Additions and Renovations
Platt Technical High School
Milford, CT

ADDENDUM NO. 3

August 2, 2019

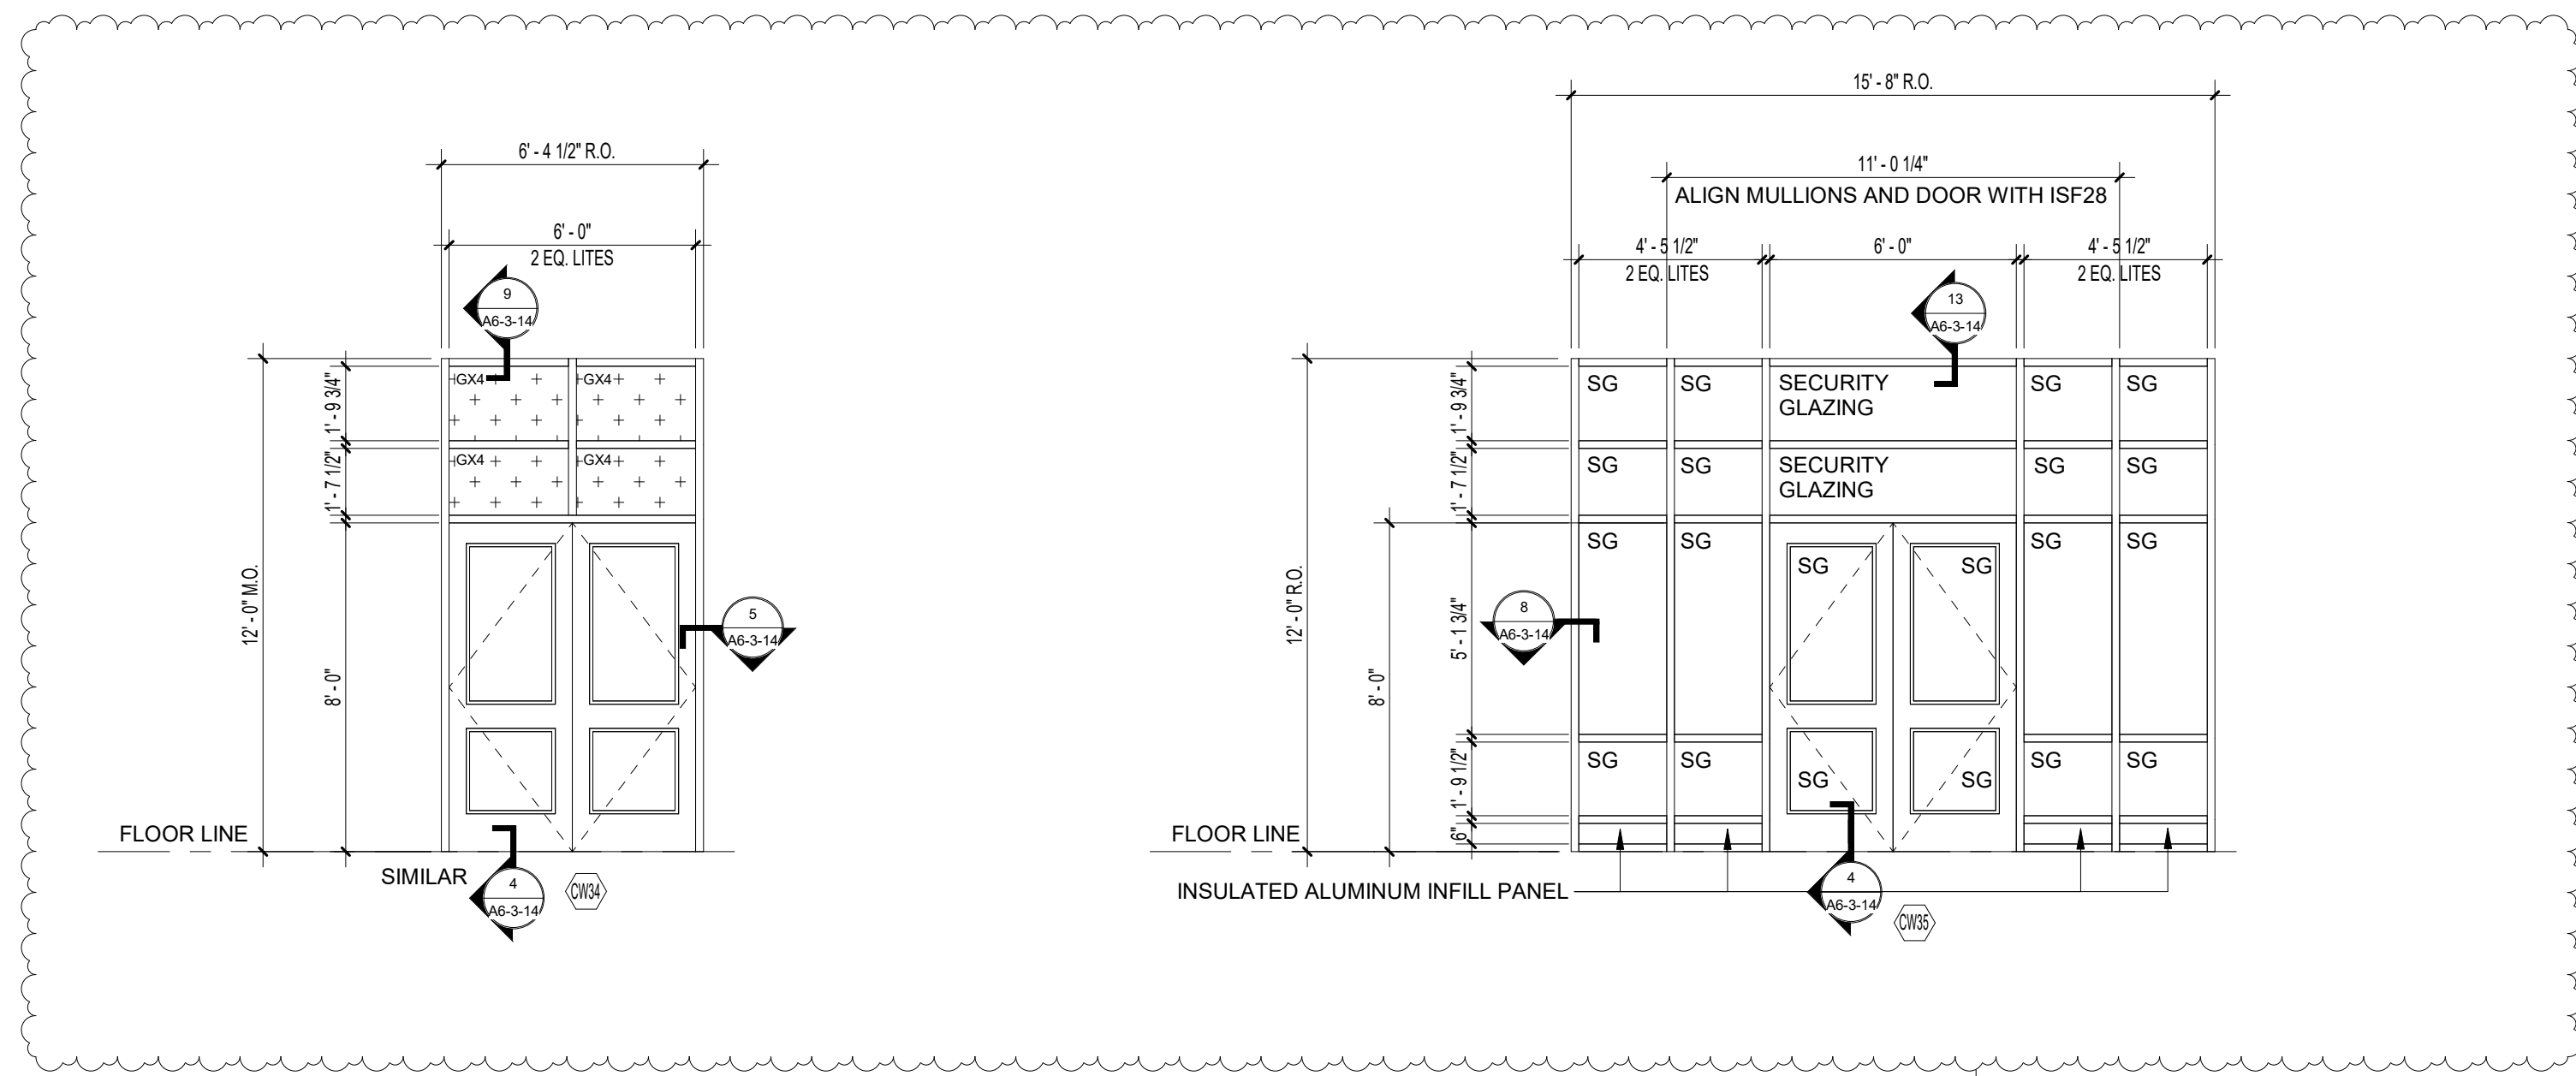
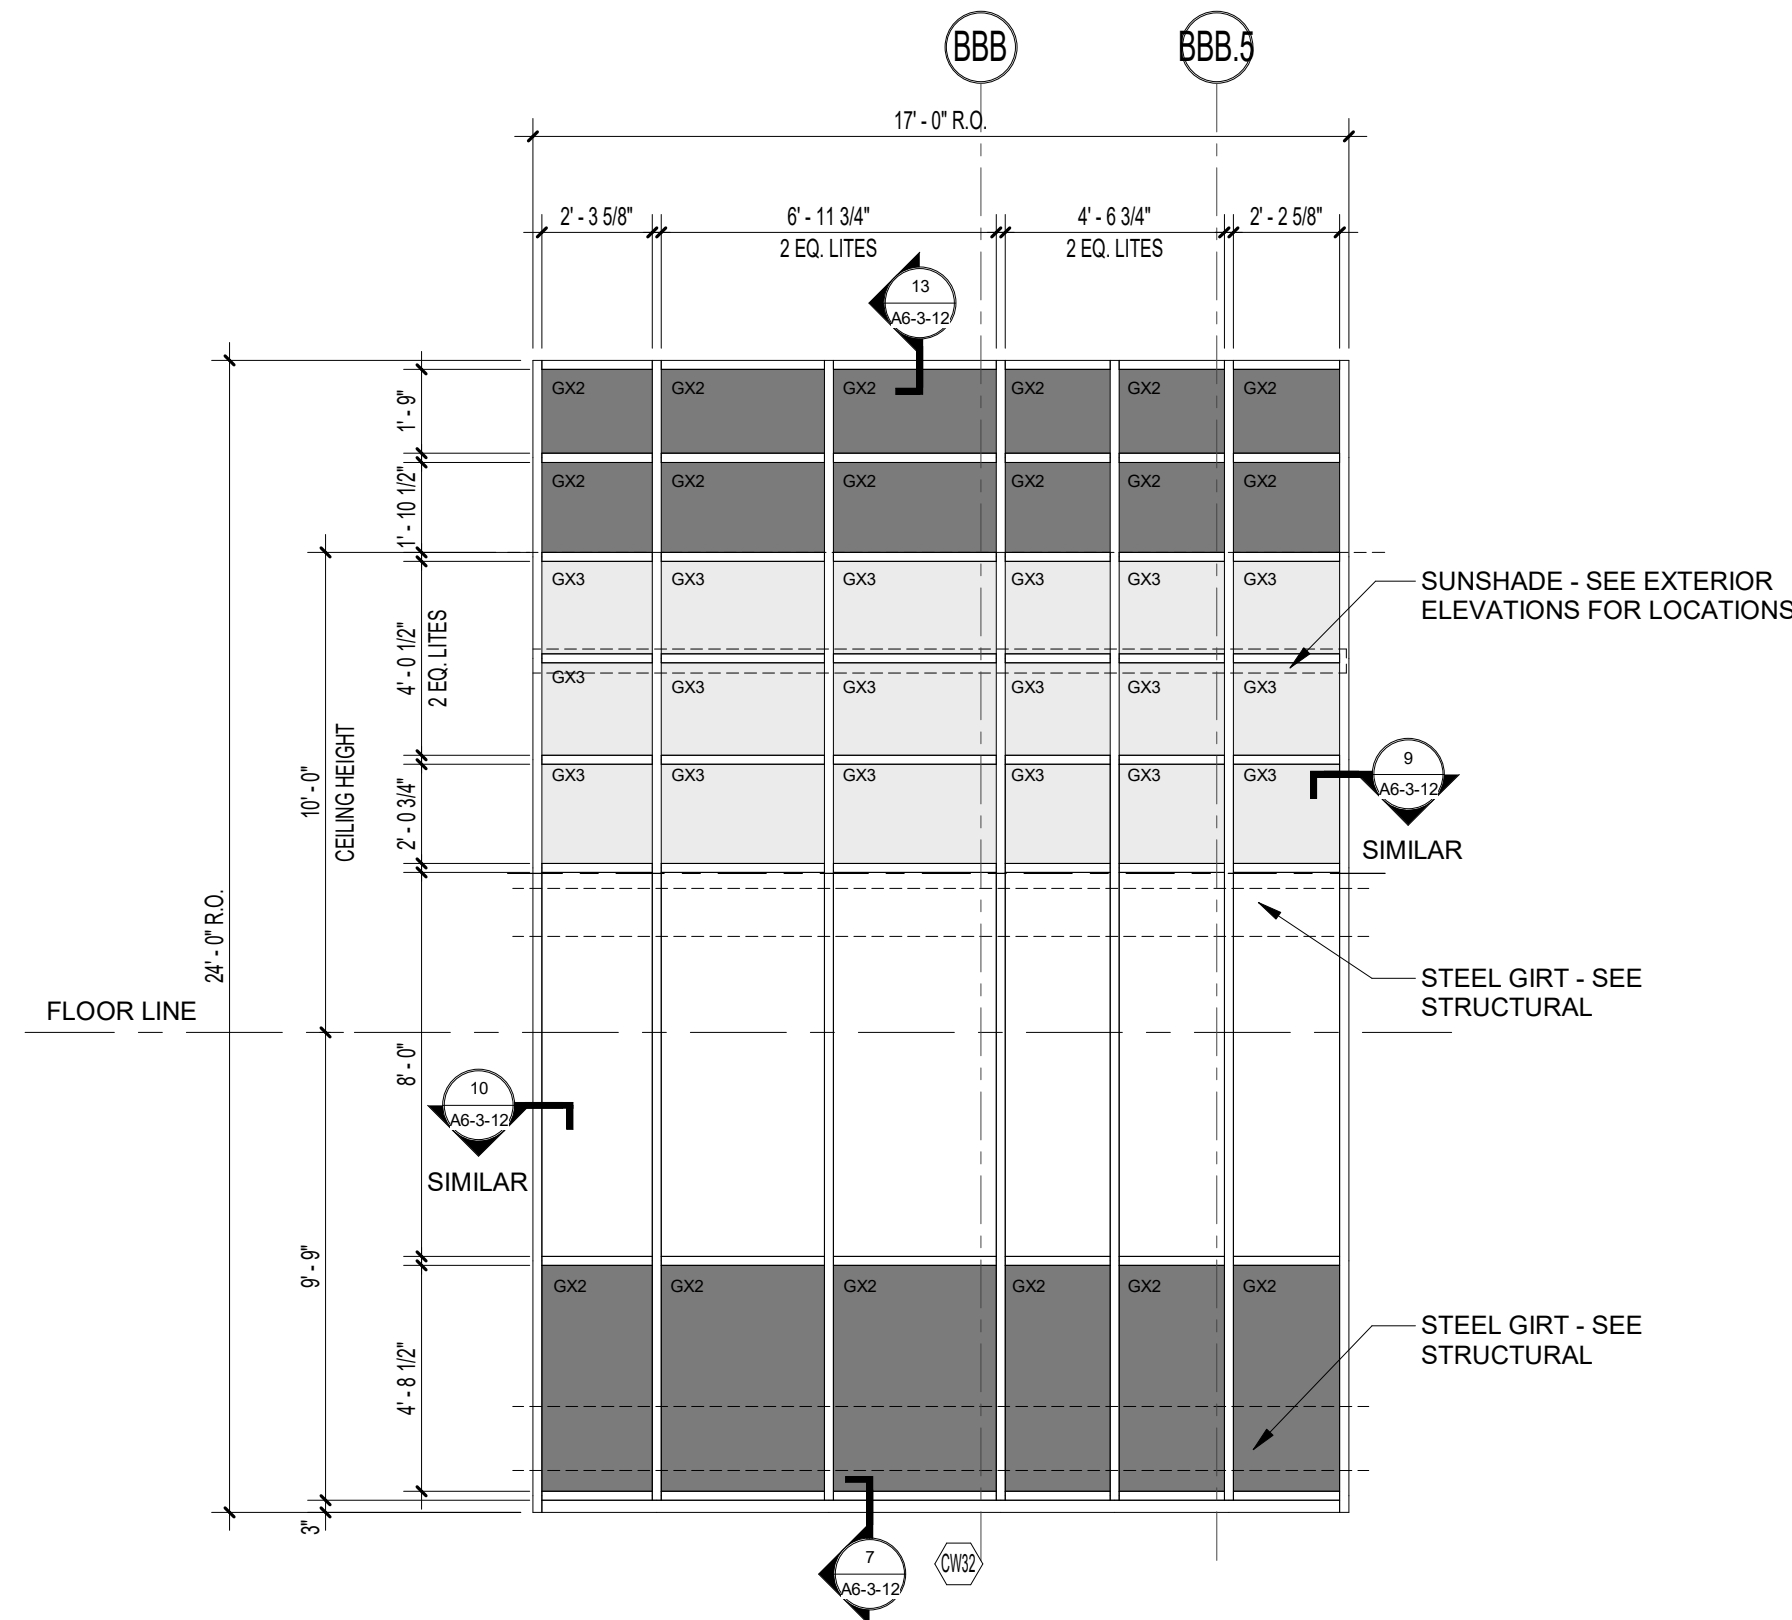
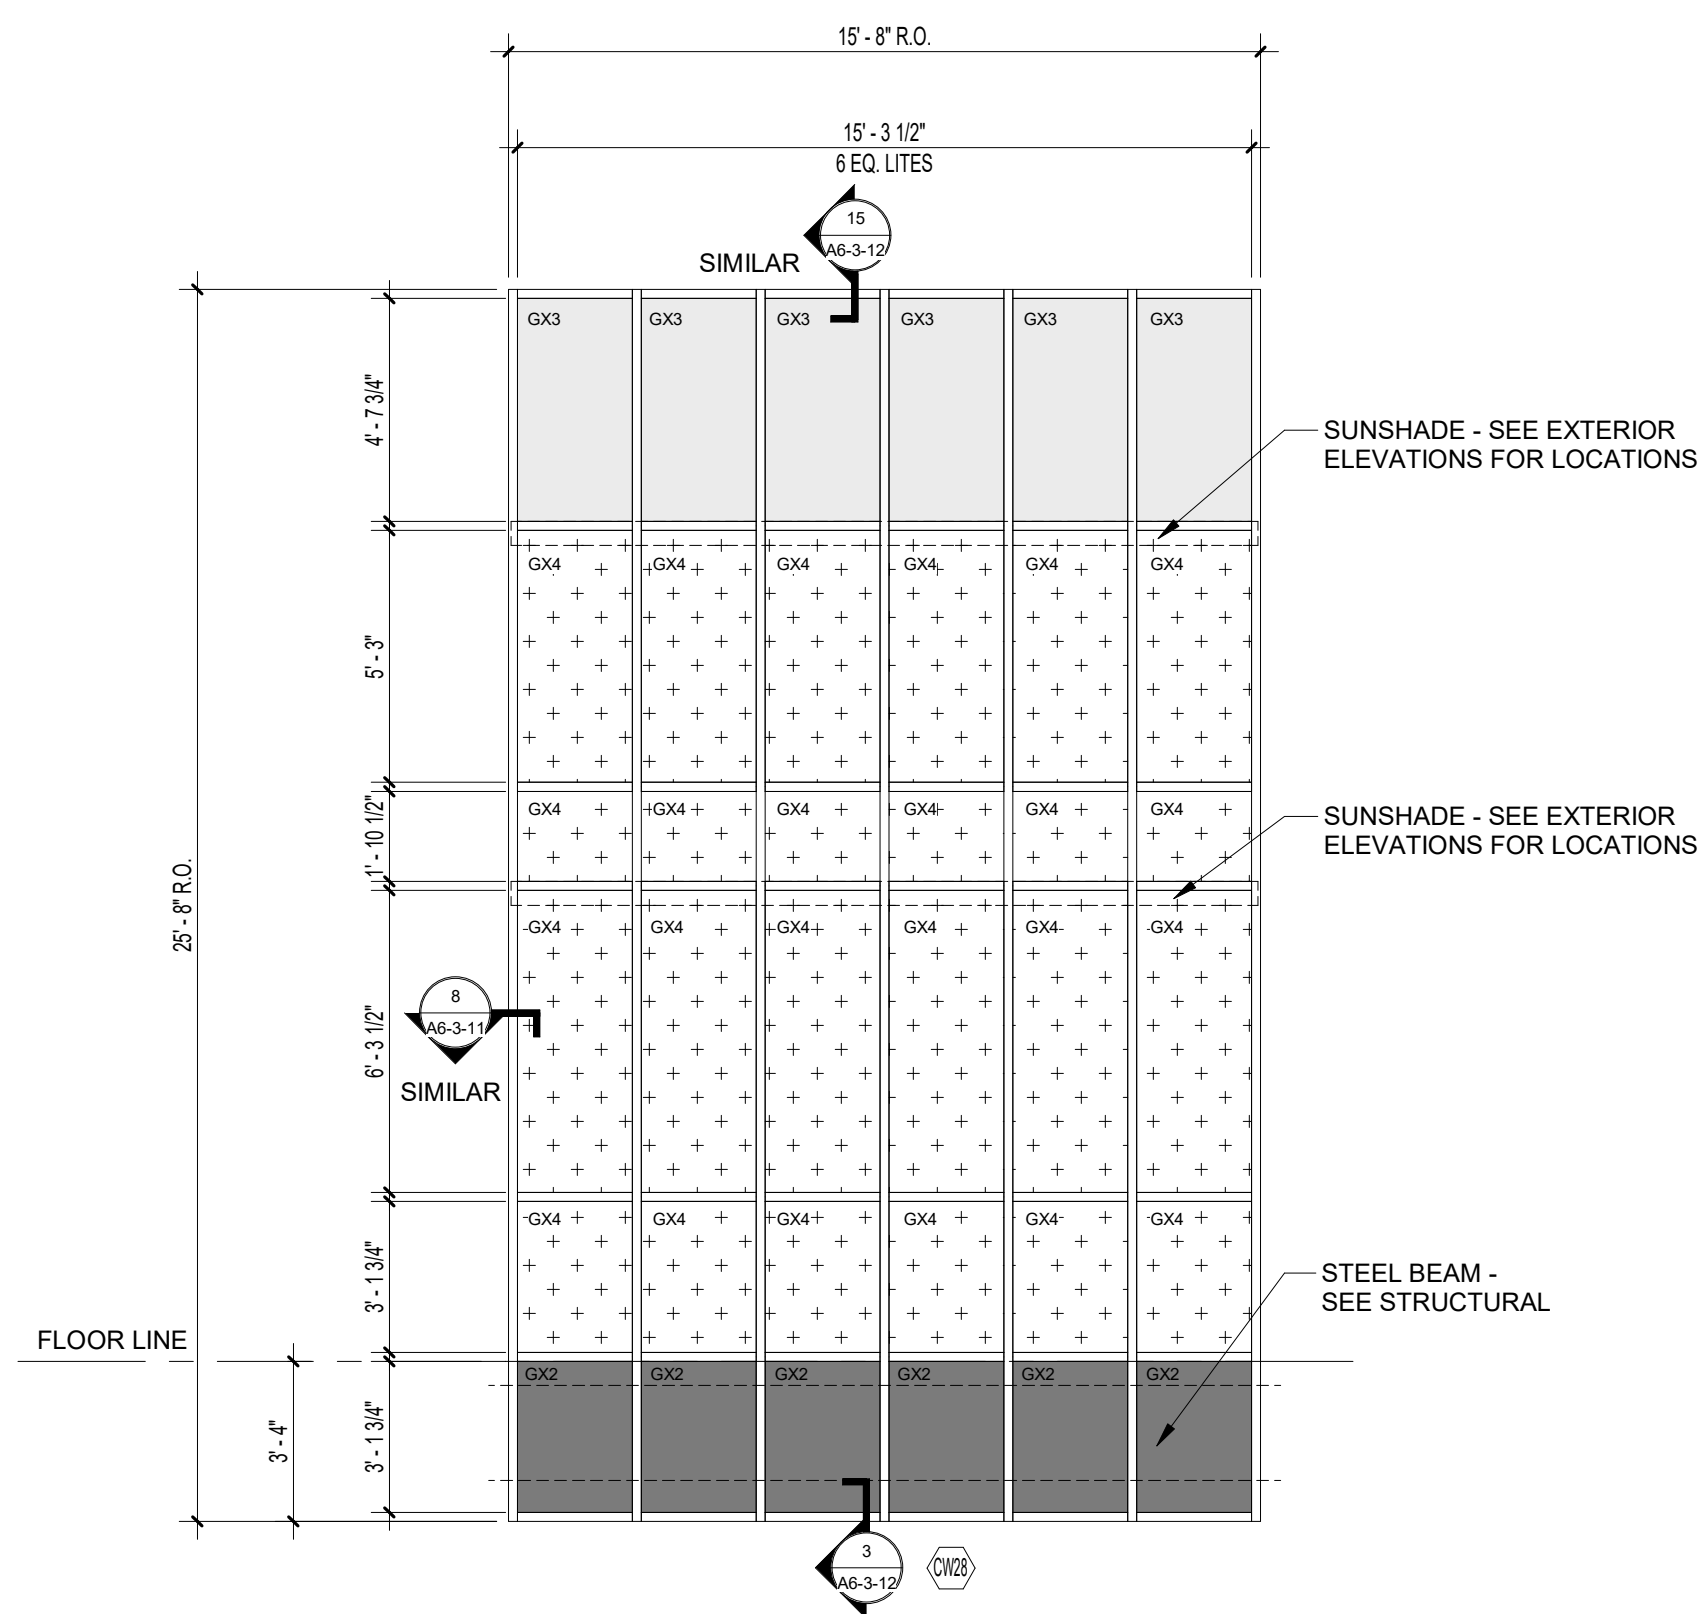
- ADD 3-062 DRAWING A2-2-3 – DOOR, FRAME AND BORROWED LIGHT TYPES**
Revised dimensions of door Types AL1 & AL2 per Sketch RA3-09.
- ADD 3-063 DRAWING A6-3-4 – CURTAIN WALL AND STOREFRONT TYPES**
Revision RA3-1:
Frame Type SF5: Revised detail tag.
Frame Type CW27: Added steel girt note.
Frame Type CW29: Added note for opening in panel.
Frame Type CW35 (*previously SF3*): Revised frame type.
